Oil Sands Environmental Coalition

2 December 2016

Re: The Imperial Oil Resources Ventures Limited Tailings Management Plan for the Kearn Oil Sands Mine OSCA Application No. 1872083

Figure 1: Expected Cumulative Tailings Under the TMF⁵

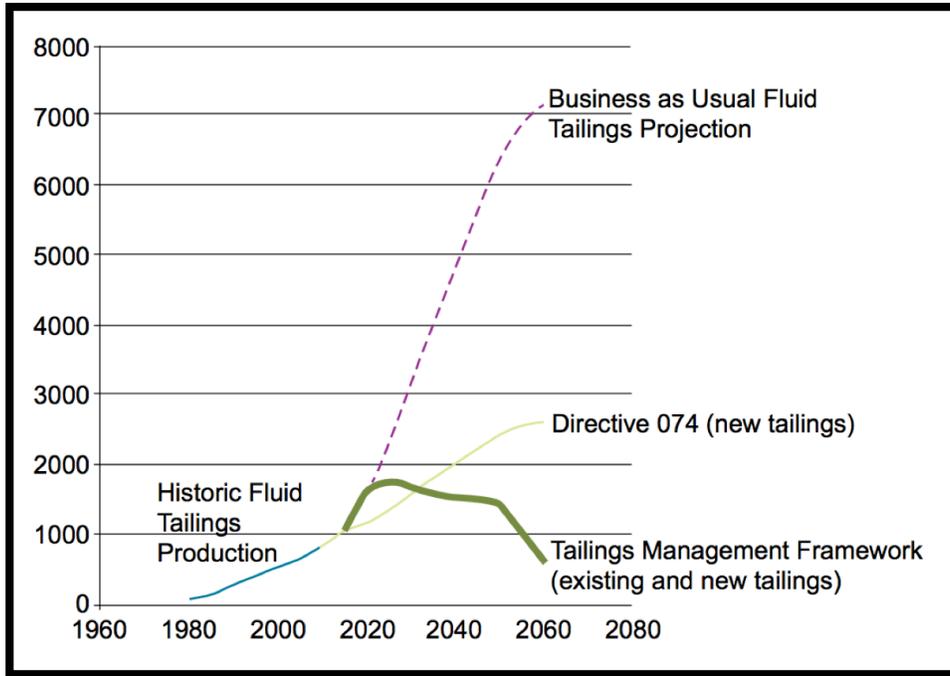
The TMF graphically outlines the expected cumulative trajectory of all fluid tailings on the landscape including a peak date for tailings accumulation, a rate of decline, and the point at which tailings cumulative tailings volumes will actually decline (**Figure 1**). OSEC has amalgamated the projected tailings volumes from all Directive 085 applications submitted to date, and compared it with the aforementioned TMF trajectory (**Figure 2**). This analysis has demonstrated a general trend wherein cumulative tailings volumes are peaking roughly ten years later than the TMF anticipated.

Figure 2: Cumulative Tailings Volumes of All Directive 085 Applications

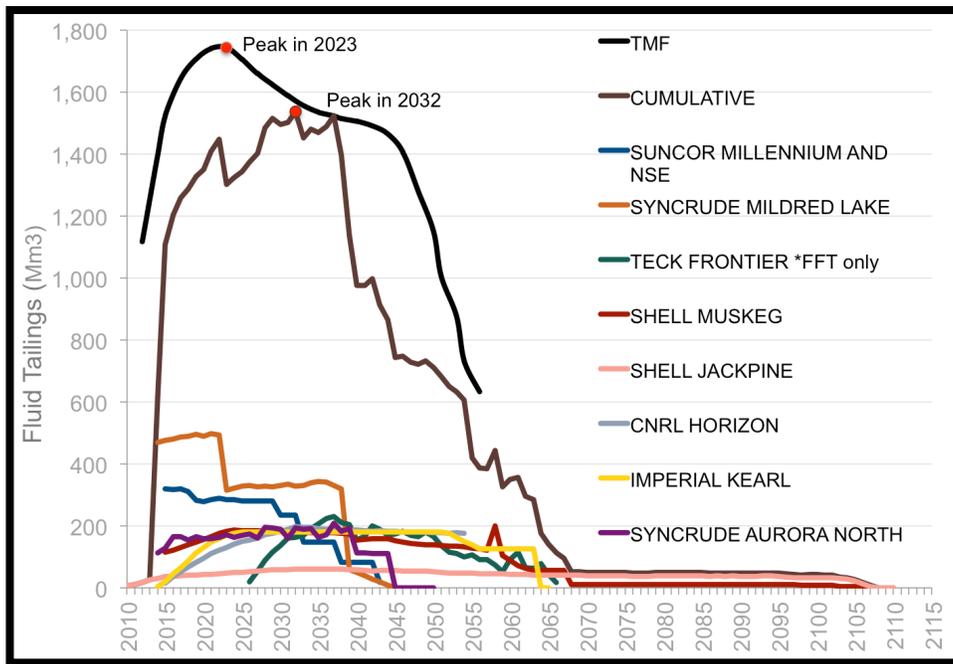
OSEC and the AER's ability to determine the adequacy of Imperial's plans are correspondingly dependent on an assessment that the sum of the approved tailings plans are consistent with the TMF's objectives. As such, it is essential for regulators and stakeholders to compare all tailings plans in conjunction to ensure responsible regulatory decisions are made. We thereby strongly recommend that no applications be approved until all proponent plans have been comprehensively reviewed.
